| Project | IEEE 802.16 Broadband Wireless Access Working Group < http://ieee802.org/16 > | |
| Title | Corrections to Figure 88 | |
| Re: | This is a contribution to IEEE 802.16 Cor1. | |
| Abstract | Corrections to Figure 88 on OFDMA PHY Periodic ranging at BS. | |

Figure 88 Periodic Ranging – Received UL Data -- BS

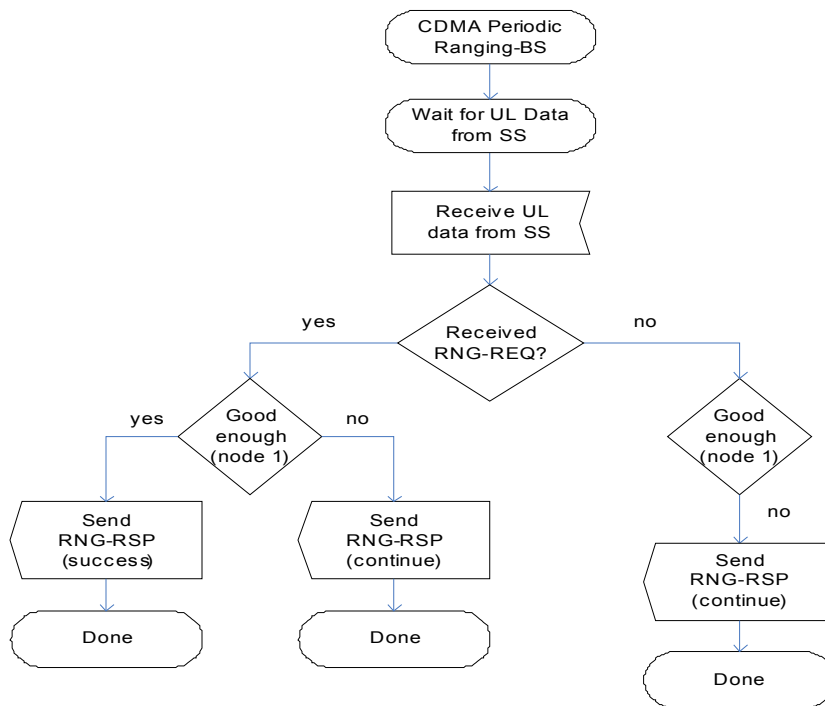
With OFDMA, the periodic ranging may be invoked at BS by either receiving CDMA ranging code (as shown in Figure 89) or receiving UL data from SS (as shown in Figure 88). However, the current Figure 88 has couple of problems, one is that it still checks if receiving ranging code after received UL data; the other is that it does not show the case of receiving RNG-REQ message.

Replace Figure 88 with the following figure:
